ADDENDUM NO. 2

December 14, 2018

HARDY TRAIL EXTENSION
DADE CITY, FLORIDA

Raised Intersection Grading Detail

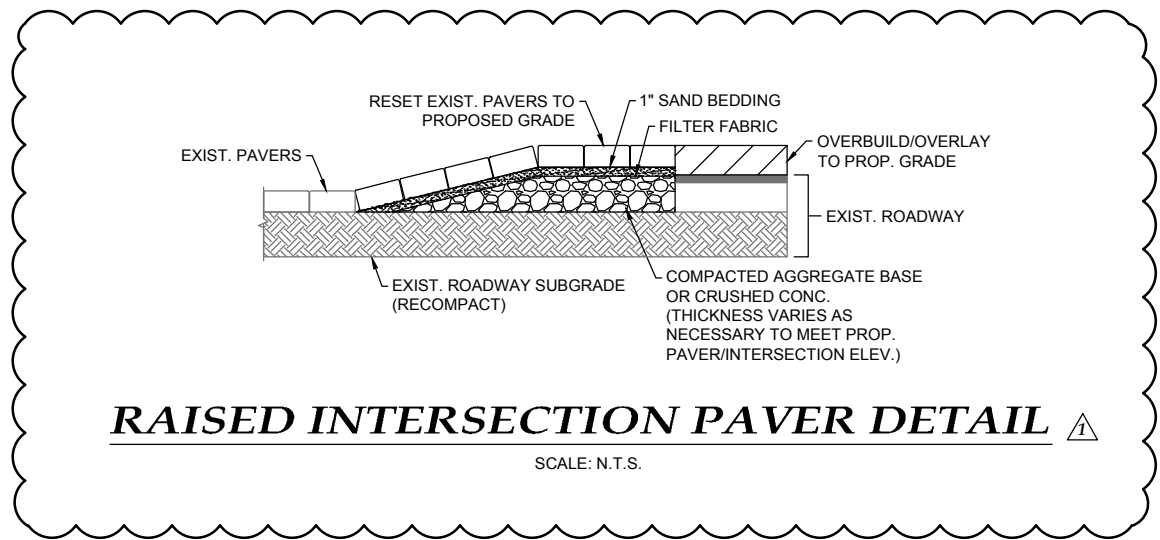
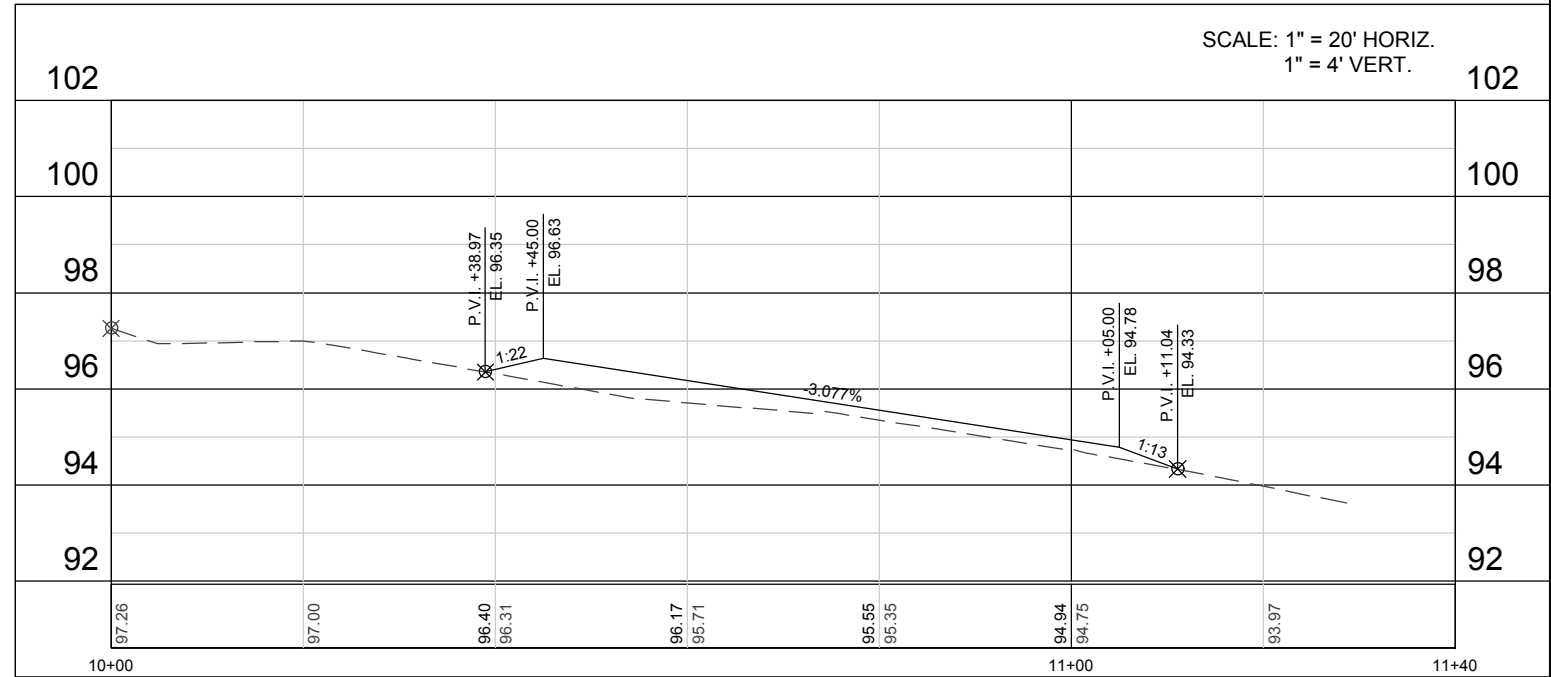
8. How is the removal and reinstallation of the brick on 10th St at MLK paid for? The “Raised Intersection Grading Detail on plan sheet 35 shows new grades extending into the brick pavement. What is the typical section for the brick pavement?

9. There is not a typical section for the MLK intersection. Are we to raise the pavement with overbuild asphalt or is it the intent to rebuild the entire intersection?

RESPONSE: The removal and reset of brick is incidental to the cost of the storm pipes and structures being installed as this operation would have been required in order to install the new pipes and structures. The material required to raise the brick was included in the quantity of asphalt overbuild, but could be replaced with Recycled Crushed Concrete or other compacted aggregate base per the added detail on Sheet 35.

RESPONSE: The raised intersection will be constructed with overbuild as shown on sheet 35. The quantity of overbuild was accounted for in the asphalt quantity.
